UNITED STATES
DEPARTMENT OF THE INTERIOR
BUREAU OF LAND MANAGEMENT
SUNDRY NOTICES AND REPORTS ON WELLS

5. Lease Serial No. NM-77046
6. If Indian, Allottee or Tribe Name
7. Unit or CA Agreement Name and No.
8. Well Name and No. North Pure Gold 9 Federal 18H
9. API Well No. 30-015-32616
10. Field and Pool, or Exploratory Upper Penn Shale
11. County or Parish State Eddy NM

Devon Energy Production Company, L. P. requests permission to increase the rig layout per the following footages:

H&P 212, 214, 232, & 372 Location Dimensions

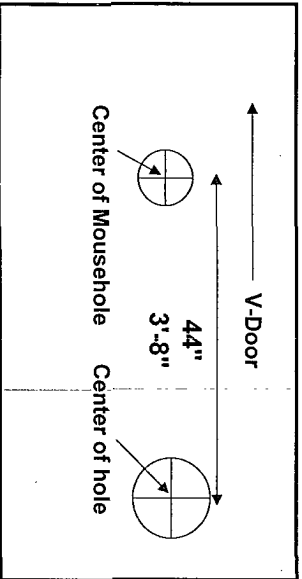
55 feet on the South
10 feet on the East
50 feet on the West
10 feet of the burm to all sides

Please see the attached approved diagram with the reflected changes.

Add 10' of
Burrow to All
Sides.
